ReA: Construction Storm Water Inspection at Clifton on the Boulevard / Franklin County. Permit Number: 4GC03961*AG

Figure 1: Failed silt fence on the north side of the site requires maintenance.

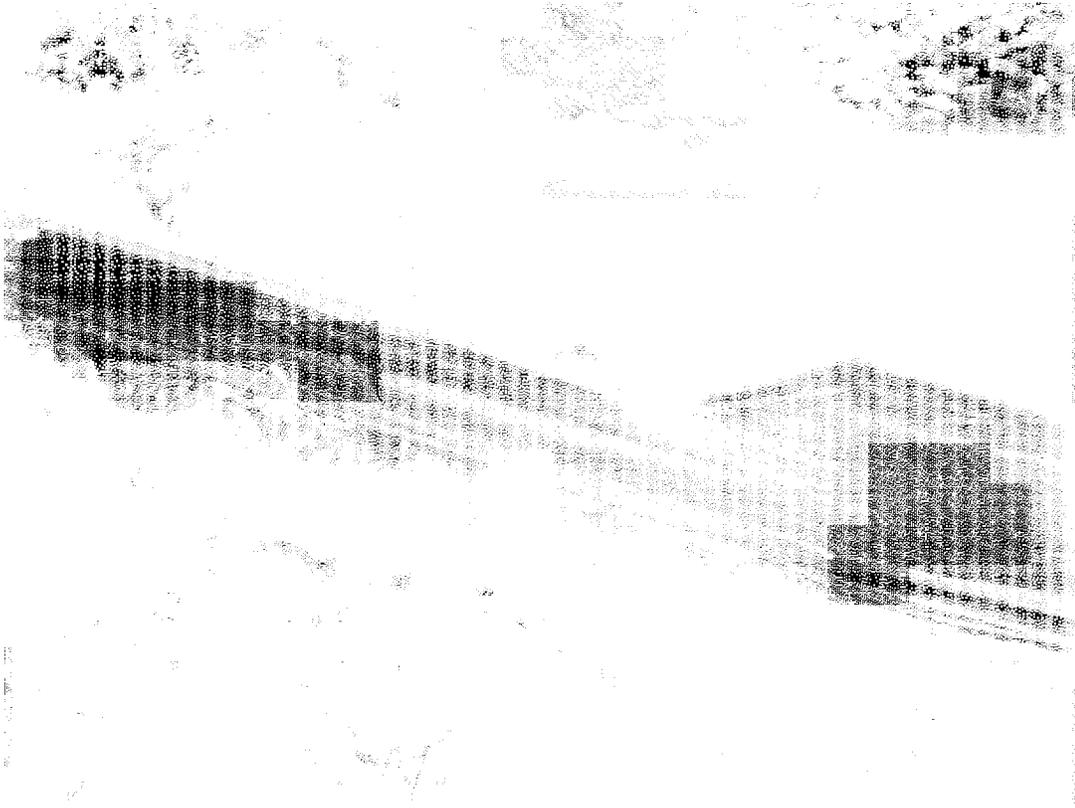
- Failed silt fence was noted in the northeast corner of the site, adjacent to the creek. Corrective measures must be implemented within three (3) days from receipt of this letter (See Figure 1).
- An outlet pipe in the northeast corner of the site appeared to contain sedimentation (See Figure 2). Please ensure appropriate maintenance of all controls within this drainage are
- Be aware the General Permit states that all barren areas which remain idle in excess of 21 days must be protected from erosion within seven days of the last earth disturbing activities. In addition, erosion protection must be implemented for all areas of final grade within seven (7) days.
